Memorandum

То		From			
Сору		Reference	EST04585 and 04586		
Date	2021-09-16	Pages (including this page)	4		
Subject	OutputOutpu

1.1 Purpose

Figure 1 Adjusted Mudies Creek Bridge Impact Area (blue outline)

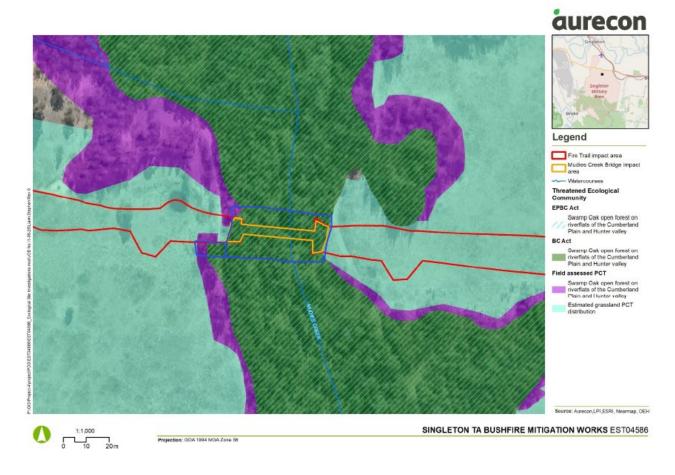
The Singleton EST04585 and EST04586 ecological assessment report (Rev2 2020-20-15) identifies the following TEC's be removed allowing for implementation of the Mudies Creek and Doughboy Hollow Creek bridges. However, adjustments are required to the area of the TEC's impact in order to accommodate bridges construction. These adjustments are identified in the table below and further identified in **Figure 1** and **Figure 2**:

TEC Impacted	Conservation Status under the EPBC Act	Initial Impacted Area	Adjusted Impact Area accommodation construction
Coast Swamp Oak (<i>Casuarina glauca</i>) Forest of the New South Wales and South East Queensland ecological community	EN	Up to 0.0748 ha	Up to 0.1380 ha
Central Hunter Valley eucalypt forest and woodland	CE	Up to 0.0014 ha	Up to 0.0110 ha
